Entergy Nuclear Operations, Inc.  
Pilgrim Nuclear Power Station  
600 Rocky Hill Road  
Plymouth, MA 02360

**SUBJECT:** Entergy Nuclear Operations, Inc.  
Pilgrim Nuclear Power Station  
Docket No. 50-293  
License No. DPR-35

Request for Amendment to the Technical Specifications (TS), Removal of  
Main Steam Isolation Valve (MSIV) Twice Per Week Testing Surveillance  
Requirement

**LETTER NUMBER:** 2.05.003

**TS page: 3/4.7-6**

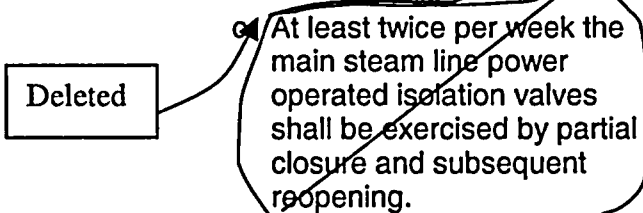
Deleted  At least twice per week the main steam line power operated isolation valves shall be exercised by partial closure and subsequent reopening.

The TS Surveillance Requirement 4.7.A.2.b.1.c is revised to state, "deleted" on TS page 3/4.7-6.
